TUALATIN CITY COUNCIL

Wednesday, August 7, 2013

SUBJECT: CONTINUANCE- Consideration of a Central Urban Renewal District **Master Plan** for the Nyberg Rivers Shopping Center Development located at 7455-7925 SW Nyberg Street (Tax Map 2S124A 2700--2S124A 1601, 1602, 1900, 2502, 2506, 2507, 2700/ 2S124B 2000, 2001, 2100) in the Central Commercial (CC), Commercial Office (CO) and High-Density Residential (RH) Planning Districts and Central Urban Renewal Blocks 1-5 (MP 13-01).

Nyberg Rivers Master Plan Public Hearing

EXHIBIT Q. 1-BUILDING FRONTAGE LANDSCAPE PLAN

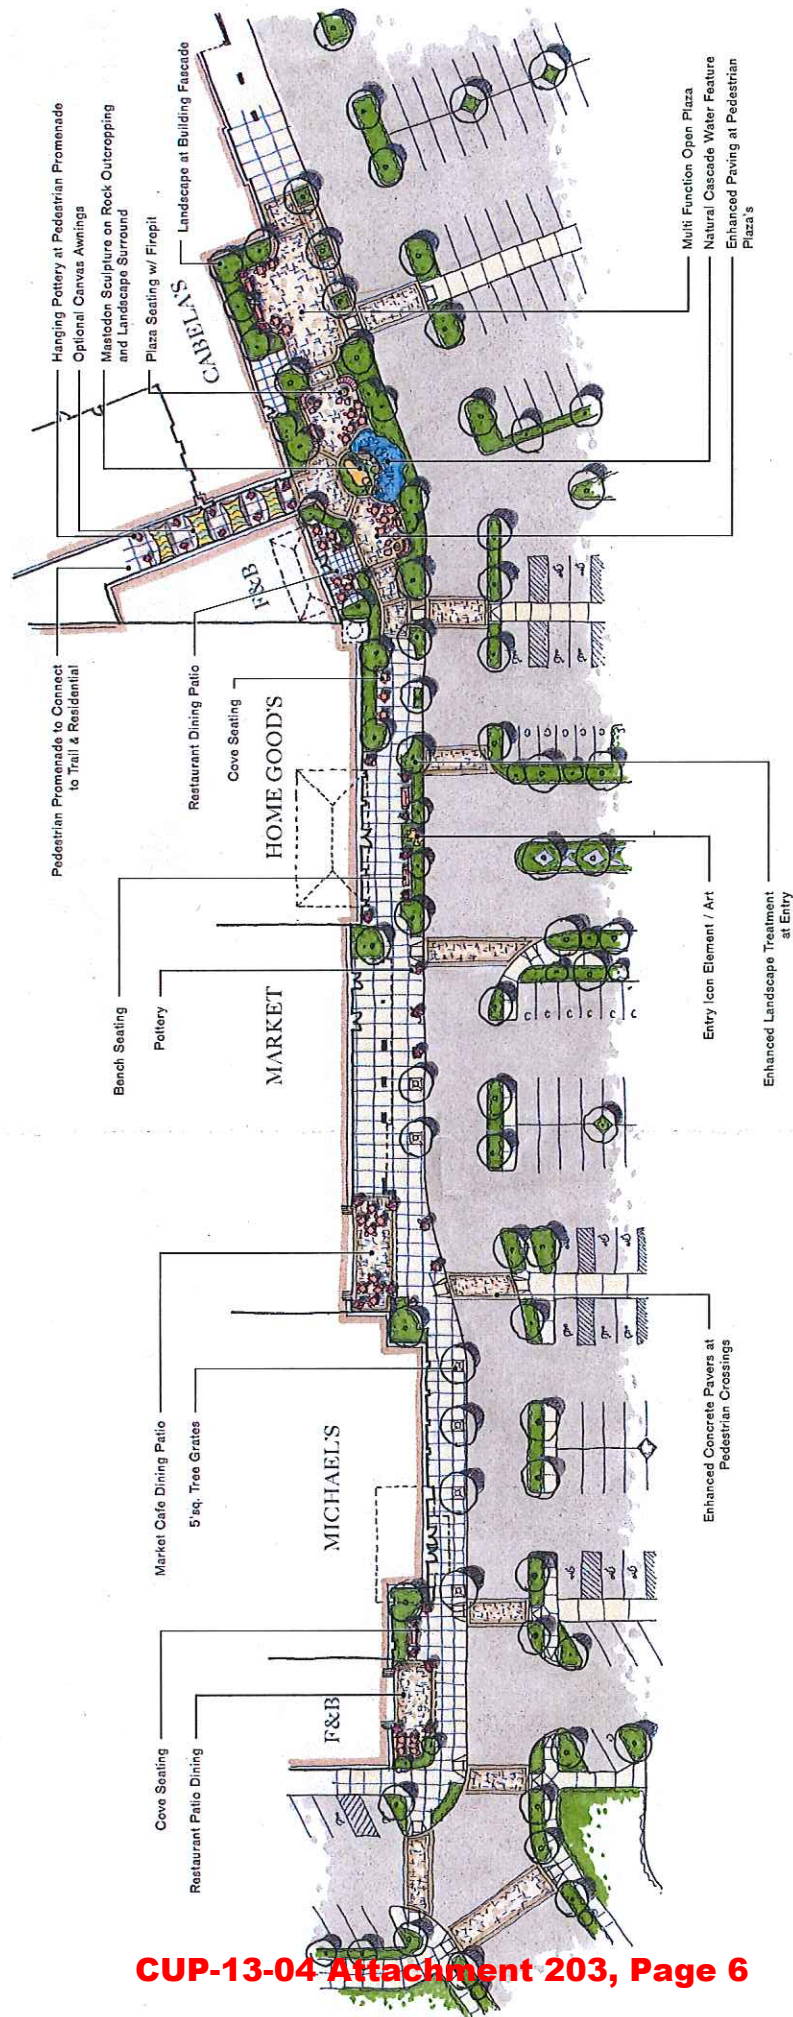
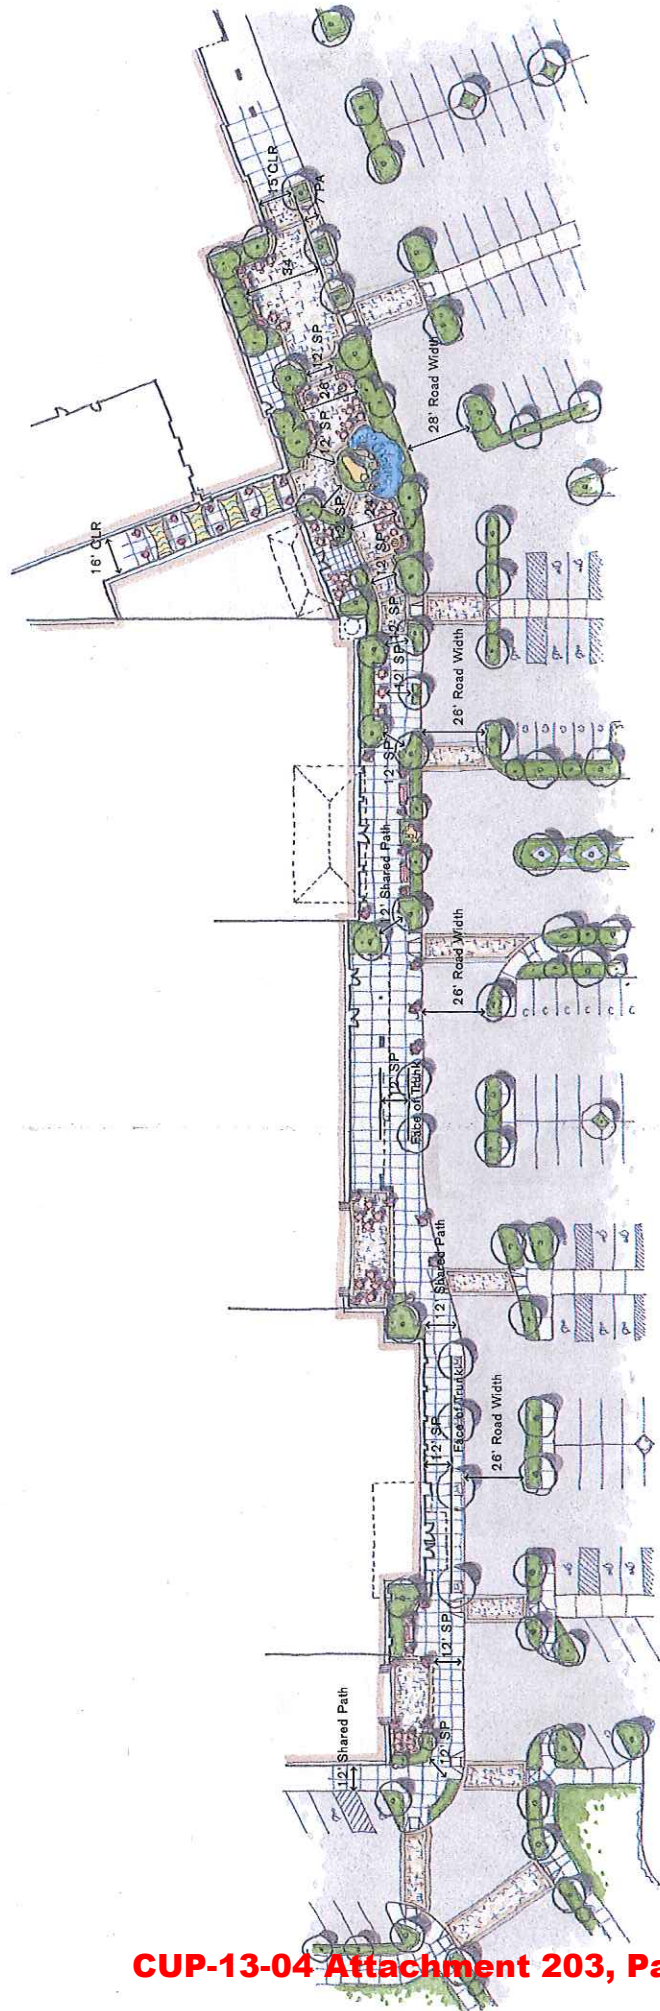
a) Recreational equipment, apparel and sports outfitting sales are prohibited in areas identified as public gathering, multi-function open plaza and plaza seating with fire pit on Attachment 102D page 60 Building Frontage landscape plan.

b) A minimum of 12 feet of clear, unobstructed width for walkways or accessways through a plaza or along the building frontage between Building D1 and northeast corner of the public gathering, multi-function open plaza seating with fire pit on Attachment 102D page 60 Building Frontage landscape plan. on the west and southeast corner of Building 1040 on the east

Recreational equipment, apparel and sports outfitting sales are prohibited in the public gathering place identified below.

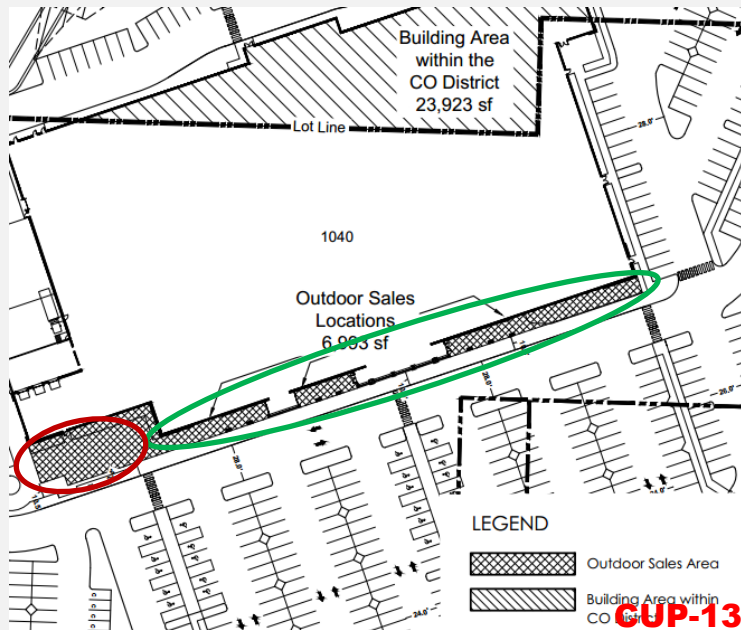
Boats, trailers, and ATVs are prohibited
